MECKLENBURG COUNTY
DEPARTMENT OF ENVIRONMENTAL HEALTH

APPLICATION FOR SOIL INVESTIGATION

APPENDIX II
SITE EVALUATION

SITE INVESTIGATION REPORT
INDIVIDUAL SEPTIC TANK SYSTEM
WITH SUBSURFACE,
SOIL ABSORPTION,
EFFLUENT DISCHARGE

* Site Plan on Back (Include Soil areas, property lines, roads, streams, gullies, wet areas, fill areas, wells, water bodies, slope patterns, etc.)

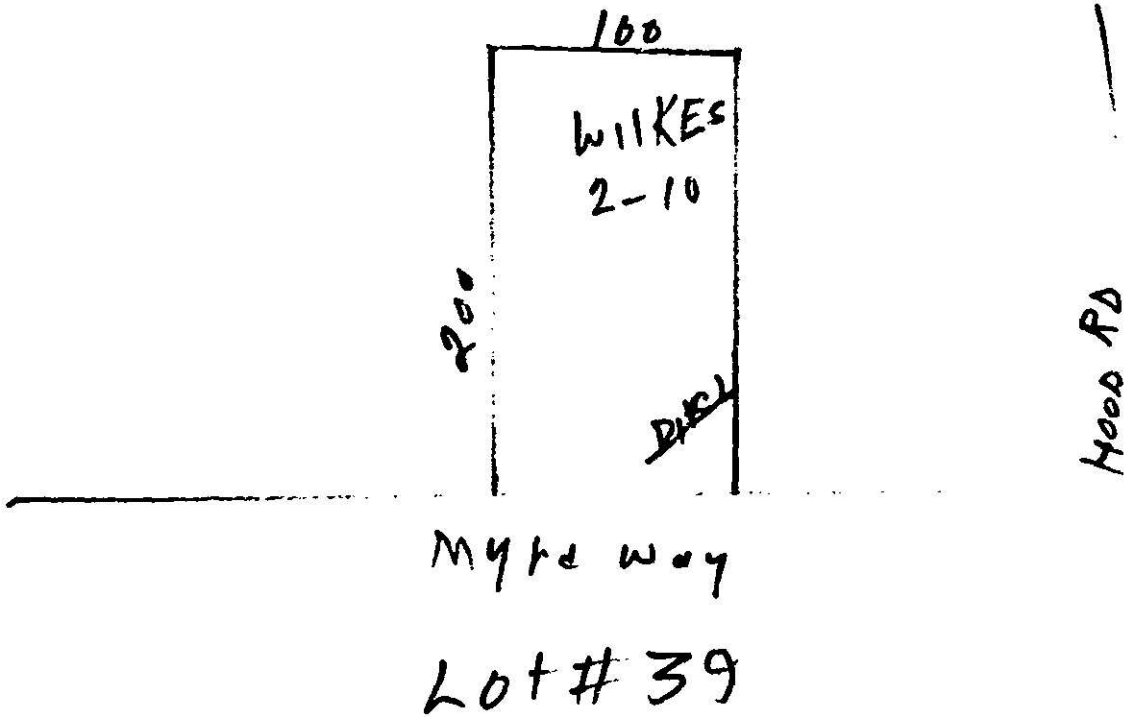
FACTORS		AREA 1	AREA 2	AREA 3	AREA 4
1. SLOPE (%)	S	2-10			
	PS				
	U				
2. SOIL TYPE (12-36 in.) (Sandy loamy clay/clay 2:1 Clay)	S				
	PS	clay			
	U	Saprolite			
3. SOIL STRUCTURE (12-36 in.) (Granular Soils)	S				
	PS	MASSIVE			
	U				
4. SOIL DEPTH (In.)	S				
	PS	48			
	U				
5. RESTRICTIVE HORIZONS (In.) (Impervious Strata, Rock)	S				
	PS	Saprolite			
	U				
6. SOIL WETNESS/GROUNDWATER (External & Internal)	S				
	PS	SLOW			
	U				
7. SOIL PERMEABILITY (Percolation Rate)	S				
	PS	SLOW			
	U				
8. OTHER (Specify)	S				
	PS				
	U				
9. SITE CLASSIFICATION		Unsuitable			
SOIL SERIES		WILKES

As determined under the Rules and Regulations promulgated by the Commission for Health Services, Division of Health Services, North Carolina Department of Human Resources, Raleigh, North Carolina, the soils on the lot described above were found to be unsuitable for the installation of an individual septic tank - soil absorption system, due to the following reason:

Soil Structure Massive

Soil Permeability Unsuitable
